**Eminent
Technology
Incorporated**

LFT-VIII Input Connections

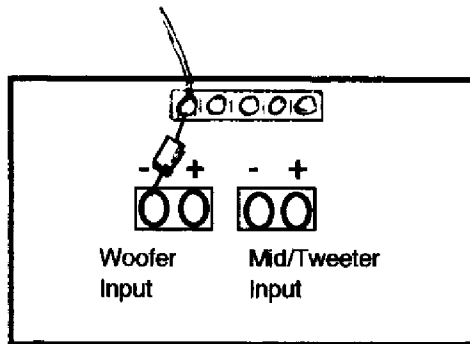
To increase the tweeter output on the LFT-8 place a 1uF or 2.2uF capacitor between the negative terminal of either the woofer or mid/tweeter input terminals on top of the woofer box to the black wire from the tweeter which attaches by spade lug to the low/mid/or high tweeter position. See the sketch below. This will increase the tweeter output. A larger value capacitor will give proportionally more output.
